AIRPORT-CODY SUBDIVISION, RESUBDIVISION

The plat illustrates the proposed 1-lot, 1.6± acre subdivision which is located on the Northeast corner of Airport Boulevard and Cody Road South, in Council District 7.

APPLICATION NUMBER 2 DATE September 1, 2016

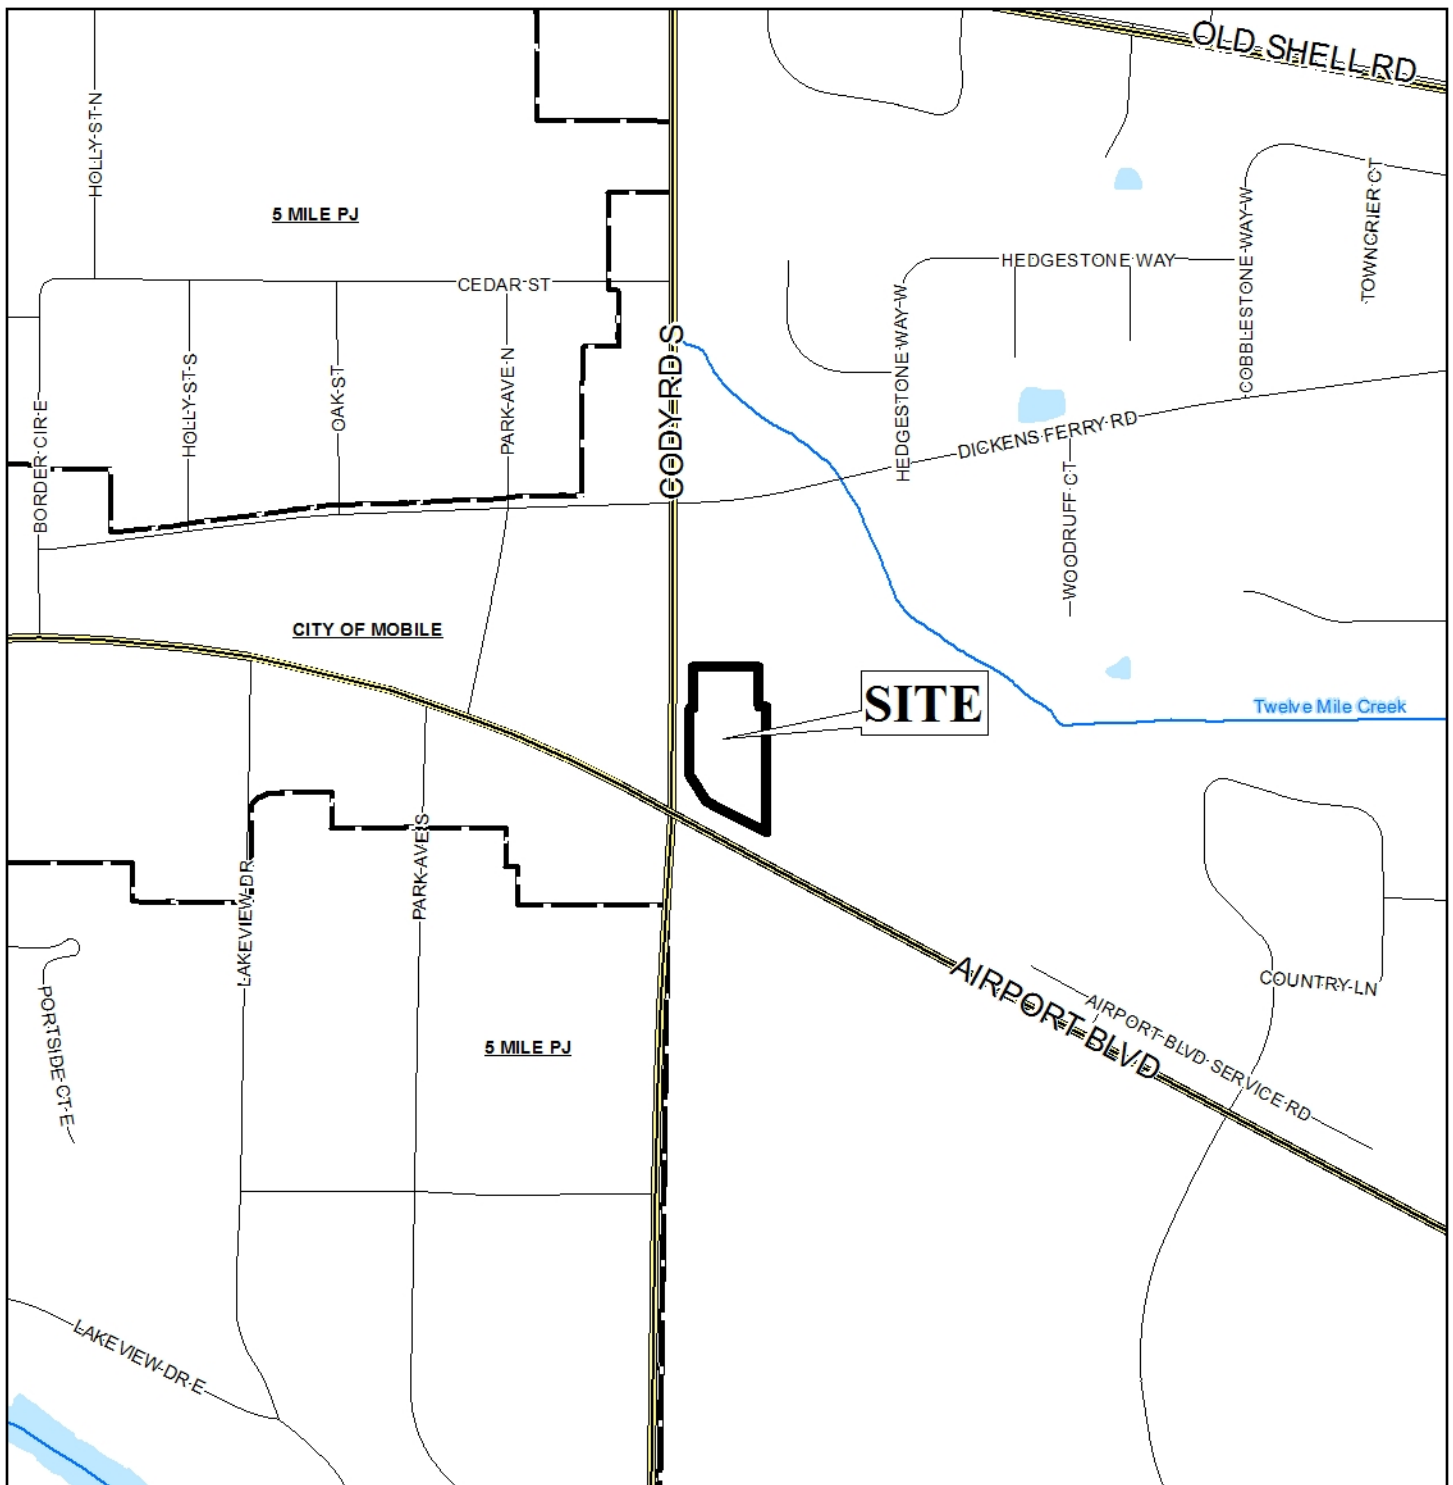
The proposed lot has frontages on Airport Boulevard and Cody Road South, both Major Streets requiring 100' right-of-way widths. The preliminary plat illustrates an adequate right-of-way width of 140' along Airport Boulevard, making no additional dedication necessary. An 80' right-of-way width is depicted along Cody Road South; and, as such, revision of the plat to illustrate dedication 50' from the centerline of Cody Road South will be required, if approved.

With regards to access management, the proposed lot currently has access to Airport Boulevard via two curb cuts and to Cody Road South via three curb cuts. However, a note should be placed on the Final Plat stating the lot is limited to one curb cut per street frontage, with any changes in their sizes, designs, or locations to be approved by Traffic Engineering and conform to AASHTO standards.

The proposed lot meets the minimum size requirements of Section V.D.2. of the Subdivision Regulations, but the lot sizes are not illustrated in either square feet or acres. If approved, this information should be provided on the Final Plat, or a table furnishing the same information should be provided.

The 25-foot minimum building setback is illustrated along all street frontages on the preliminary plat. If approved, this information should be retained on the Final Plat.

- 1) revision of the plat to dedicate 50' from the centerline of Cody Road South;

- 2) placement of a note on the Final Plat stating the lot is limited to one curb cut per street frontage, with any changes in their sizes, locations, or designs to be approved by Traffic Engineering and conform to AASHTO standards;

- 3) revision of the Final Plat to illustrate the lot sizes in square feet and acres, or the furnishing of a table on the Final Plat providing the same information;

- 4) retention of the 25' minimum building setback line along all street frontages on the Final Plat;
- 5) compliance with Engineering comments: (*FINAL PLAT COMMENTS (should be addressed prior to submitting the FINAL PLAT for acceptance and signature by the City Engineer): A) Provide all of the required information on the SUBDIVISION PLAT (i.e. signature blocks, signatures, certification statements, written legal description, required notes, legend, scale, bearings and distances) that is required by the current Alabama State Board of Licensure for Professional Engineers and Land Surveyors. B) Provide the Surveyor's, Owner's (notarized), Planning Commission, and Traffic Engineering signatures. C) Add a note to the SUBDIVISION PLAT stating that a Land Disturbance permit will be required for any land disturbing activity in accordance with Mobile City Code, Chapter 17, Storm Water Management and Flood Control; the City of Mobile, Alabama Flood Plain Management Plan (1984); and, the Rules For Erosion and Sedimentation Control and Storm Water Runoff Control. D) Add a note to the Plat stating that the approval of all applicable federal, state, and local agencies (including all storm water runoff, wetland and floodplain requirements) will be required prior to the issuance of a Land Disturbance permit. E) Add a note that sidewalk is required to be constructed, and/or repaired, along the frontage of each lot, or parcel, at time of new development or construction, unless a sidewalk waiver is approved. F) Provide a copy of the revised original Final Plat and the original when submitting for City Engineer signature.*);
